Project: CFT Axial **Doc. No:** A1030114

Subject: Modifications to AFE Boards to allow for single-sided XING clock

Figure 2

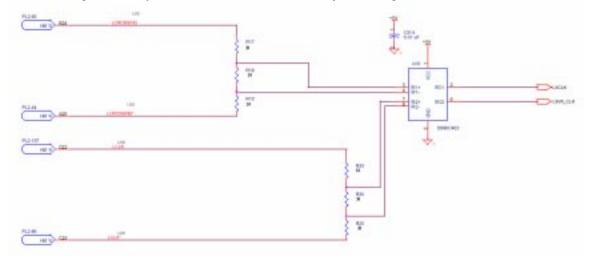
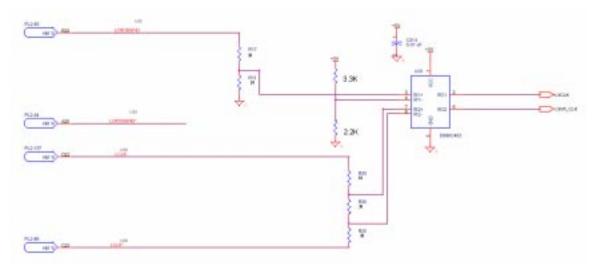
To change the circuit for single-ended operation, the '-' input of the LVDS receiver (pin 4) is disconnected from the input by desoldering and lifting the pin in the air. Two new resistors of 2.2K and 3.3K are connected in series from +5V to GND to create a voltage divider generating 2V at the centerpoint. Pin 4 is connected to this 2V reference. The '+' half of the differential signal is reterminated by removing the 51 ohm resistor connected to the '-' half of the XING signal and the center resistor. One of the removed 51ohm resistors is then soldered from the '-' input to GND, creating an 102 ohm termination and signal divider. The new effective circuit is shown in Figure 2.
